ORIGINATION FORM

Proposed Revisions to a Standard Plans Index
(Please provide all information — Incomplete forms will be returned)

Index Number: 440-002
Sheet Number (s): 1 of 3
Index Title: Underdrain Inspection Box

UNDERDRAIN INSPECTION BOX ASSEMBLY

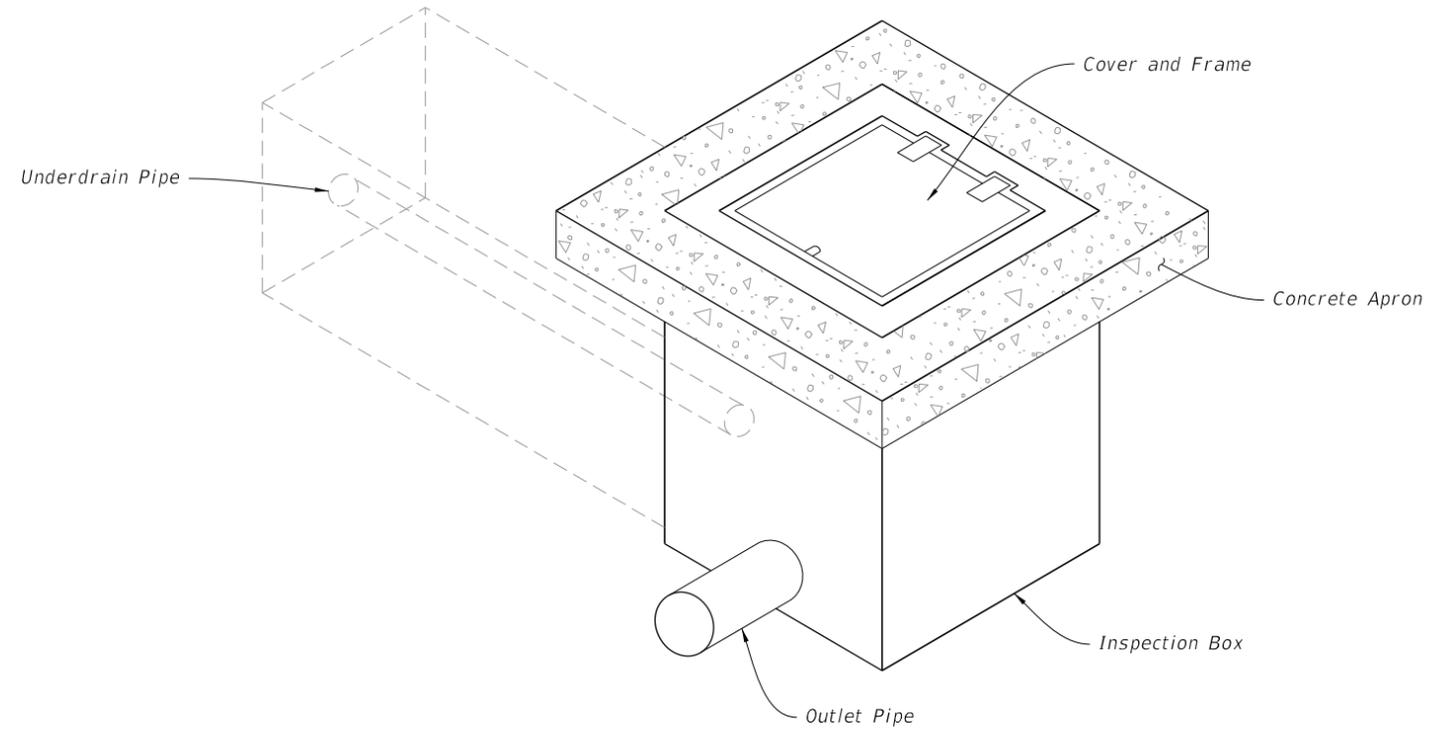
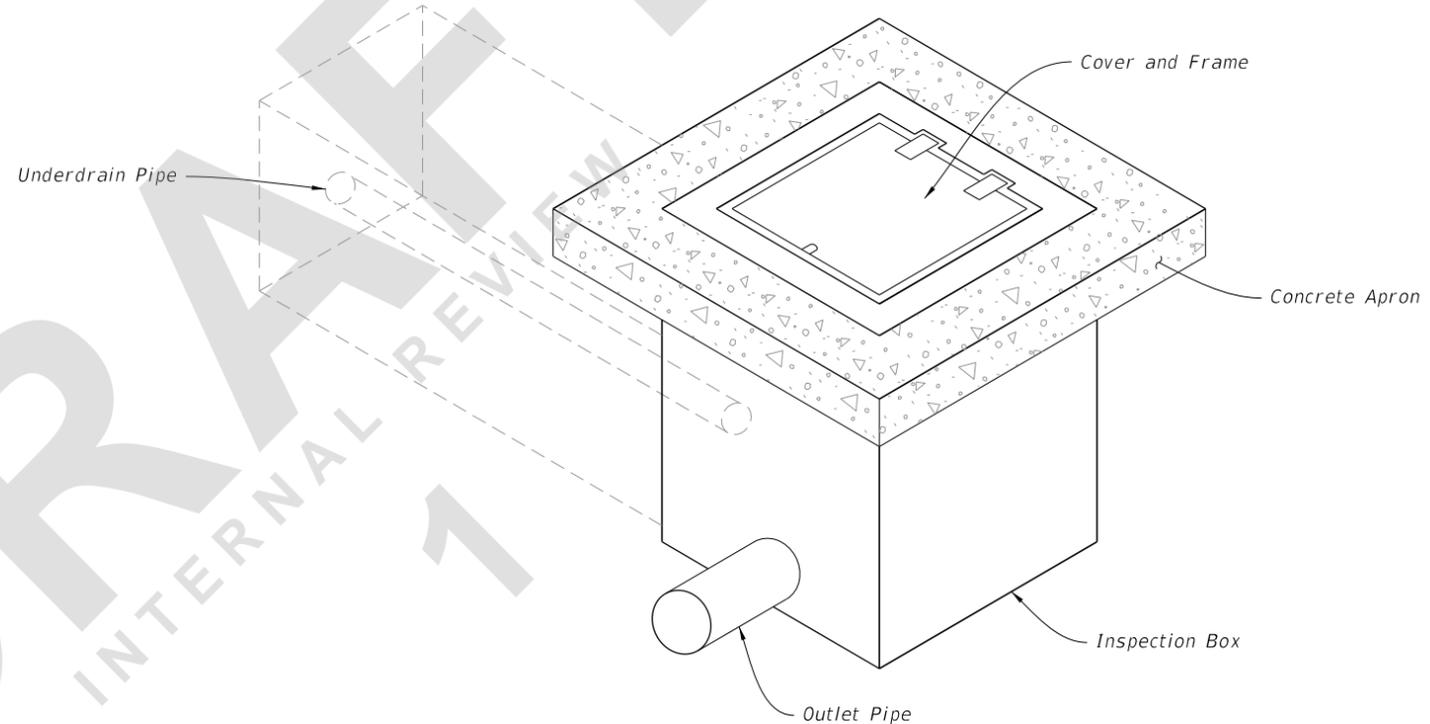
Sheet 1: Changed GENERAL NOTE 2 from "Class I" to "Class II".

Changed to reflect Materials specification change that removes the designation for Class I Concrete.

CHANGED TO: Class II

1. Install light duty cast iron cover and frame in accordance with Specification 962.
2. Use Class II concrete. Use No. 3 bars (Grade 60) on 8" centers both ways, sides and bottom.
3. Furnish covers with pick holes. Do not use fitted lifts or handles.
4. Manhole Type P Alternate A, Index 425-010, Type I Frame and Cover, Index 425-001, may be used in lieu of the box detailed in this Index.
